Appendix D - Landscape character and visual impact assessment addendum

MRI 82 - BRIDGE STREET, WINDSOR
**REPLACEMENT OF WINDSOR
BRIDGE**
**LANDSCAPE CHARACTER AND
VISUAL IMPACT ASSESSMENT**
ADDENDUM 01

APRIL 2013

Figure 1.1: Proposed changes to the project. The previous design presented in the EIS is shown in red.

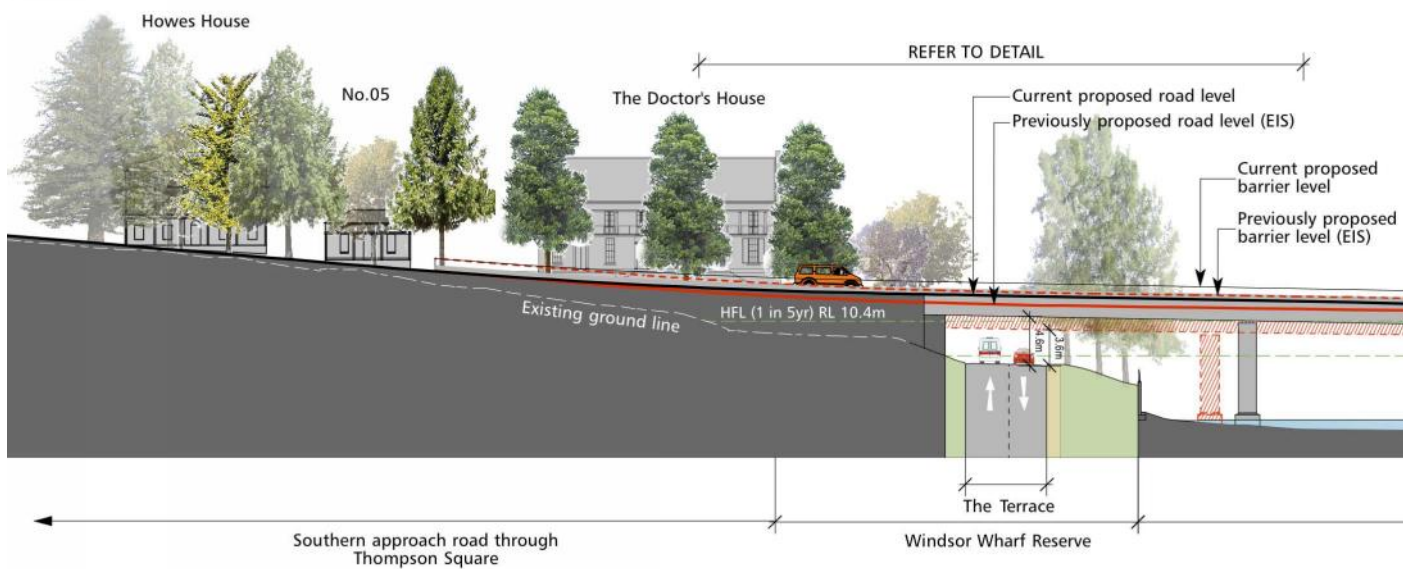
To provide the additional clearance over The Terrace the height of the southern end of the proposed bridge would be increased. This would result in a one metre higher bridge and abutment at the southern end - and a marginally higher 45 metre section of the southern approach road through Thompson Square between the driveway of No. 4 Bridge Street to the southern abutment. South of the driveway of No. 4 Bridge Street and in front of the heritage listed properties of No. 6 and No. 10 Bridge Street, the height of the southern approach road would remain the same as that presented in the EIS. The road level grade of the bridge would also increase slightly from 1.6% to 1.9%.

The location of the piers would be slightly changed so that they are evenly spaced across the river, supporting equal spans of 31.32 metres along the length of the bridge. The proposed location of the piers are also shown in Figure 1.1. No changes to the abutments are proposed.

Relatively minor amendments to the bridge piers are also proposed. The ovoid pier shape would be replaced by an oval shape to allow hydraulic jacks to be positioned on top of the pier columns at periodic times for bearing replacement. The width would be reduced from 3 metres to 2.5 metres to suit the solid girder shape and the requirement to include a restraint corbel on the inside of the girder related to a change in bearing type from pot to laminated elastomeric bearings.

Figure 1.2: Detail section at The Terrace.

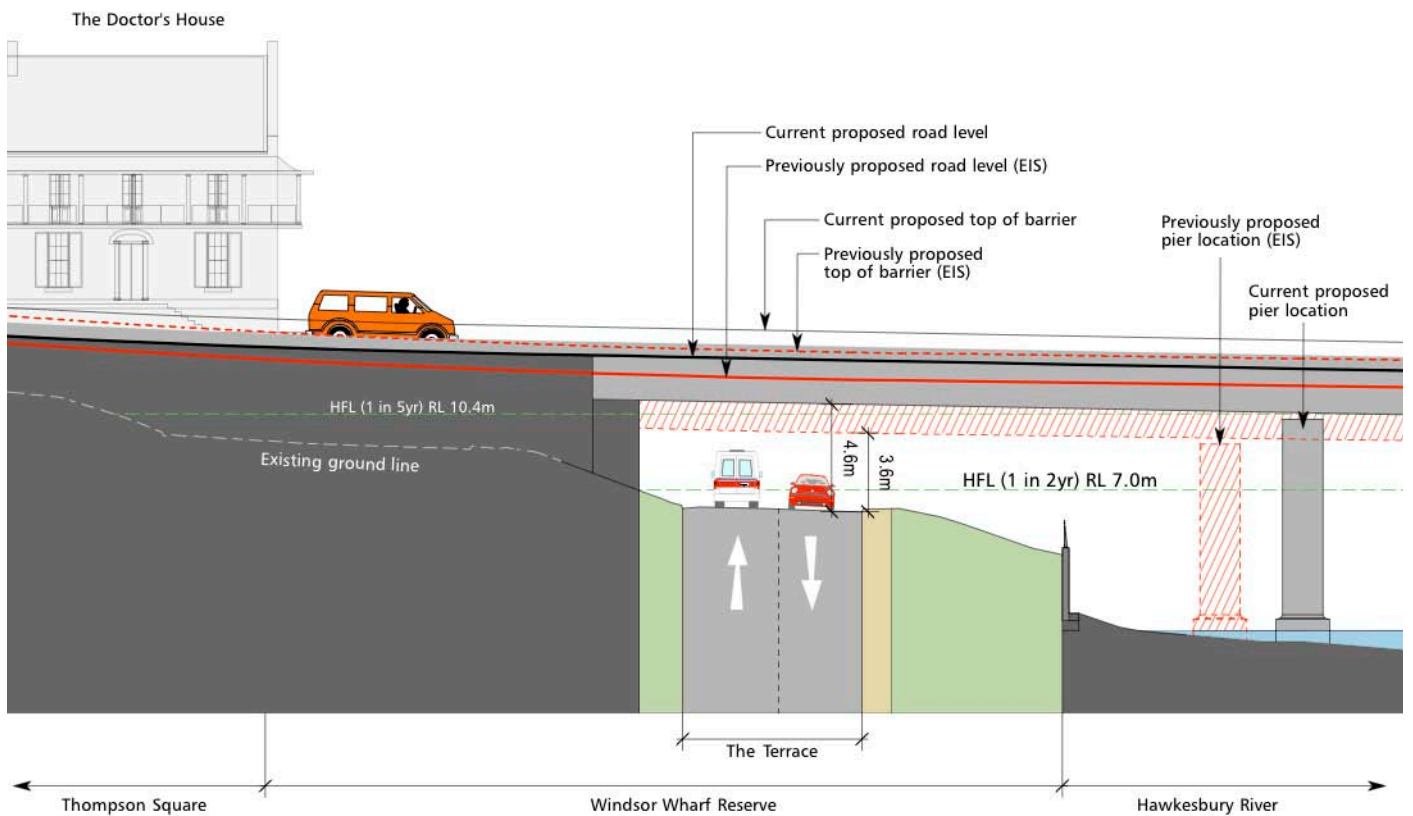
In response to a number of submissions received during the exhibition of the EIS, Roads and Maritime Services (RMS) propose to amend the design to increase the clearance of the new bridge over The Terrace from a minimum of 3.6 metres to a maximum of 4.6 metres to allow large coaches and garbage trucks to directly access Windsor Wharf. Large coach access to Windsor Wharf is required to allow the patrons of the Hawkesbury Paddlewheeler to have easy access to the wharf. Many of the patrons of the Windsor paddle steamer are elderly, disabled and/or have limited mobility and would find it difficult or impossible to access the wharf if existing arrangements were changed and large coaches were restricted to parking in Thompson Square road or Baker Street.
